### BRIAN TAYLOR STATE FIRE MARSHAL

RE: 2018 NC Residential Code (NCRC) Table R302.1 Exterior Walls

This letter is in response to your request for a formal interpretation from the Office of State Fire Marshal ("OSFM") dated 1/23/25 and received by OSFM the same day. This formal response letter serves to complete the documentation requested by William Wood of Guilford County. Thank you for your patience in waiting for this formal interpretation response while our office handled other commitments. Requests are addressed below in the order in which they are posed.

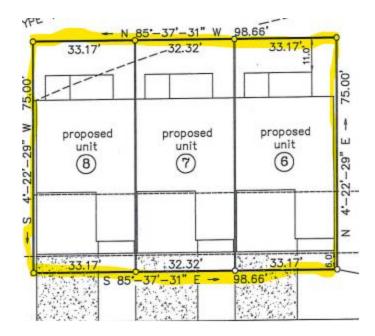
I am writing to request a formal interpretation of section R302.1, Table R302.1, previous formal interpretations and the requirements of HB 166/SL 2024-49. They seem to be conflicting, and the "sunset" date appears to be when the new code is approved, and changes are made. However, there are no changes specific to townhomes that I can see in the copy of the 2024 NCRC that I have from the engineering newsletter links. Units 6 & 8 are the specific units in question, but the project is just starting so they will all be questionable with a 0 deeded lot line. In the "Site plan" PDF the distances between buildings is shown as well as the "deeded property lines" around the groups of townhomes. The sides are a 0 setback, the front is 8' and the back is 11'. I tried requesting a deed restriction during review per the interpretations but was told that it was unclear........ Hence the reason I am seeking clarification. The word doc. Is a copy of both code tables from 2018 & 2024, HB 166 & a link to the interpretation. The "completed form" PDF is the required Appendix E form for request for formal interpretation.

Below is a snapshot of what I received from permit application for a site plan. The highlighted line is confirmed as the portion that the owner will own, all other is common area."

Conclusions: 2018 NCRC, Table R302.1 requires the exterior walls of all buildings and structures within the scope of the 2018 NCRC to have a minimum of a 1-hour fire-resistance rating if the minimum fire separation distance to the closest interior lot line is less than 3 feet. 2018 NCRC, Table R302.1 allows the exterior walls of all buildings and structures within the scope of the 2018 NCRC to have a 0-hour fire-resistance rating if the minimum fire separation distance to the closest interior lot line is more than or equal to 3 feet. North Carolina General Assembly Session Law 2024-49, Section 2.2 provides an exception for the end walls of townhouse end units only to the requirements of 2018 NCRC, Section R302 and Table R302. Per the law, the end wall of a townhouse end unit that is allowed by 2018 NCRC, Table R302.1 to have a 0-hour fire-resistance rating may be located less than 3 feet from the closest interior lot line when exterior elements of an adjacent townhouse or building added later are located at a distance equal to or greater than 6 feet. If the added adjacent townhouse or building is located less than 6 feet from a townhouse with a 0-hour fire resistance rated end wall, a minimum cumulative fire-resistance rating of 2 hours shall be provided between the two townhouses or building and townhouse.

OakdaleForest Site plan.pdf

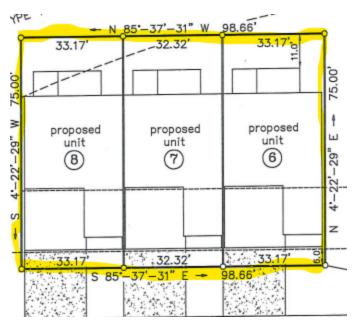
I am writing to request a formal interpretation of section R302.1, Table R302.1, previous formal interpretations and the requirements of HB 166/SL 2024-49. They seem to be conflicting, and the "sunset" date appears to be when the new code is approved, and changes are made. However, there are no changes specific to townhomes that I can see in the copy of the 2024 NCRC that I have from the engineering newsletter links. Units 6 & 8 are the specific units in question, but the project is just starting so they will all be questionable with a 0 deeded lot line. In the "Site plan" PDF the distances between buildings is shown as well as the "deeded property lines" around the groups of townhomes. The sides are a 0 setback, the front is 8' and the back is 11'. I tried requesting a deed restriction during review per the interpretations but was told that it was unclear....... Hence the reason I am seeking clarification. The word doc. Is a copy of both code tables from 2018 & 2024, HB 166 & a link to the interpretation. The "completed form" PDF is the required Appendix E form for request for formal interpretation.

Below is a snapshot of what I received from permit application for a site plan. The highlighted line is confirmed as the portion that the owner will own, all other is common area.
